RE: Update on Structural Shoring for Damaged Roof Section
Ref. Drawings:
JM Albain Engineering, Dwgs S-1 to S-6 dated 10/25/10
Dwgs. S-6, S-7 rev. 1, (DCN #1) dated 01/26/11
Project # JMA10-327-06

DCN # 2

STRUCTURAL ARRANGEMENT PLAN FOR ROOF SHORING
(FRONT)

Subject: Oswegatchie Fire Station
Inspection /Assessment: Building Structural Safety
Project # JMA22-327-062

DC2-1

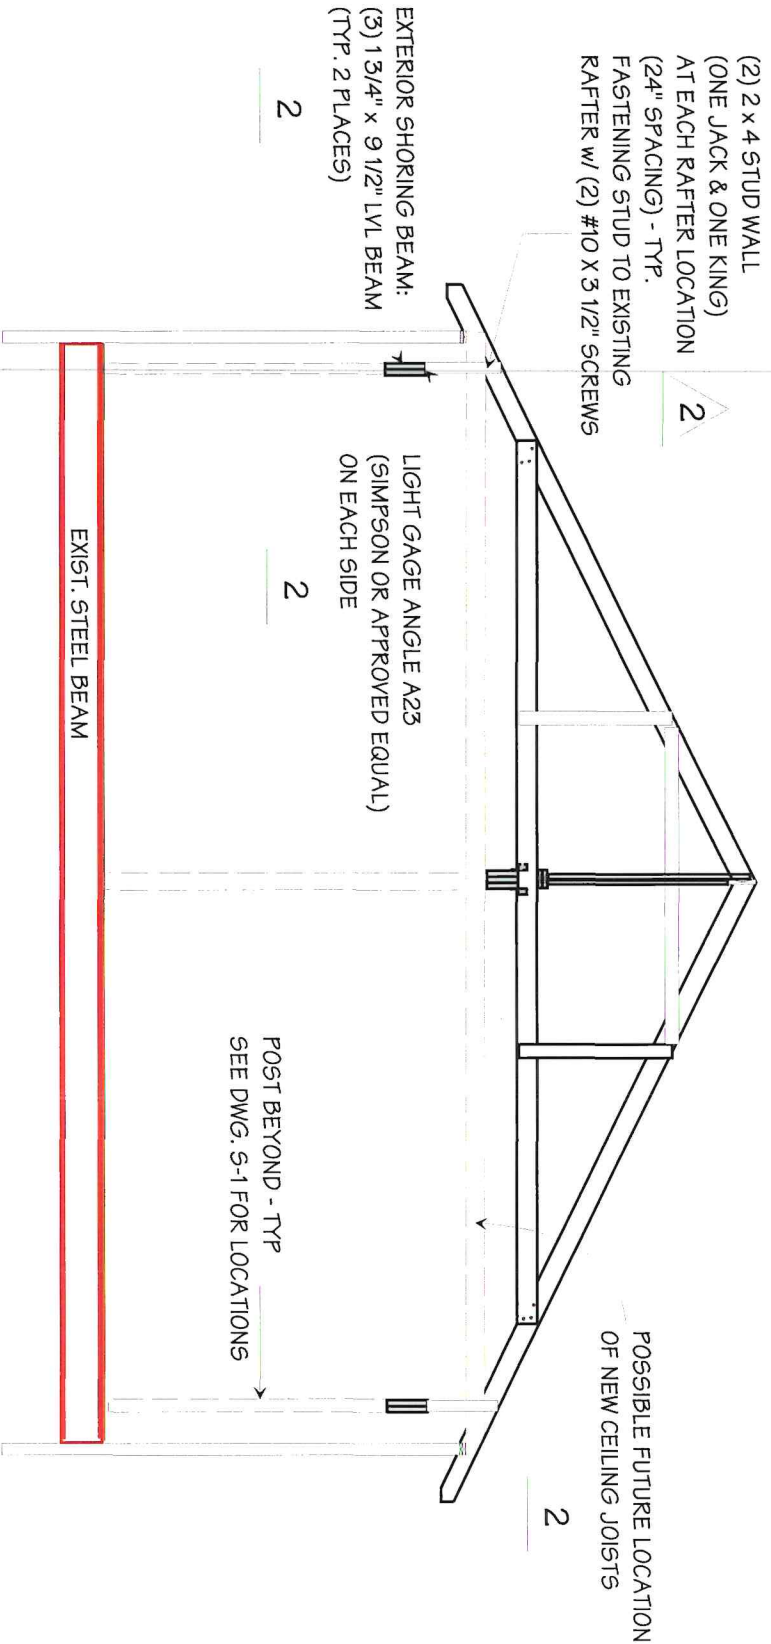
4. The new temporary roof supporting beams over the first floor Day Room and Kitchen will need to be increased to triple LVL's from double LVL's since we will need to cantilever those beams at each end of the room to avoid additional expensive work on the exiting features in the these rooms.

INTERSECTION PLANE BETWEEN
THE TWO MAIN ROOFS
FRAMING FOUND IN A VERY
WEAKENED STATE - SURVEY COMPLETELY
AFTER THE INSTALLATION OF THE SHORING

THE FINAL LOCATION OF THESE 3 COLUMNS
TO BE DETERMINED AFTER CEILING IS REMOVED

TEMPORARY SUPPORT BEAM: (3) 1 3/4 x 9 1/2" LVL

CANTILEVER
MAX. 2'-6"

CONCEPTUAL DESIGN FOR ROOF REINFORCEMENT
(FOR PRELIMINARY CONSTRUCTION ESTIMATE COST)

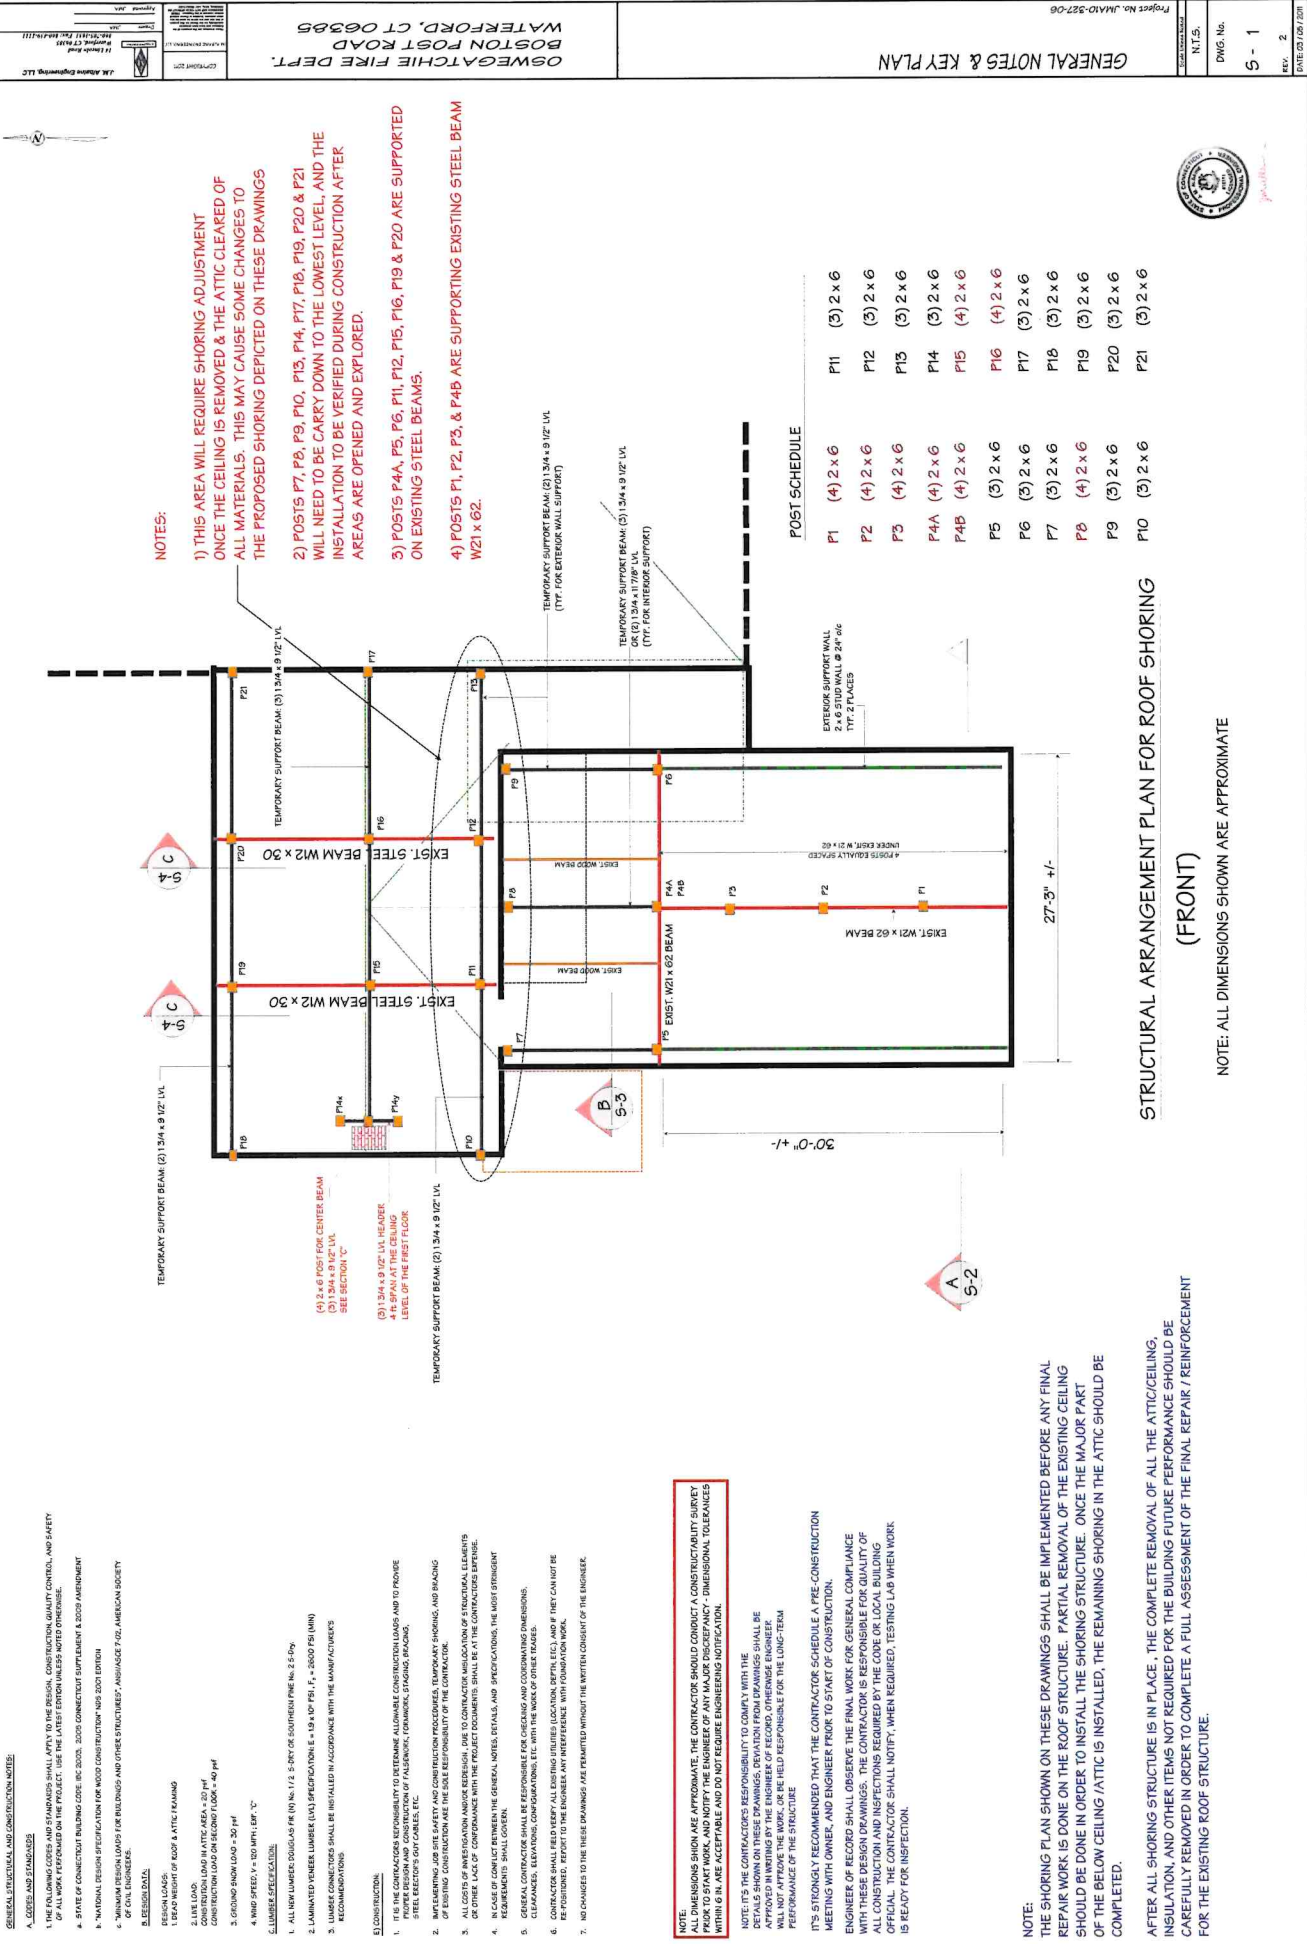
Reinforce existing roof in place as shown on Dwg. S-5. This option will not remove the current deflection (sag) on the ridge, but it will provide a strong roof capable of resisting the current building code load requirement. The "roof sag" will not be noticeable from the inside as the new inside ceiling finish will be plumb and straight.

Note that this is a conceptual design and that more analysis is required to develop the final design reinforcement to fit the existing condition.
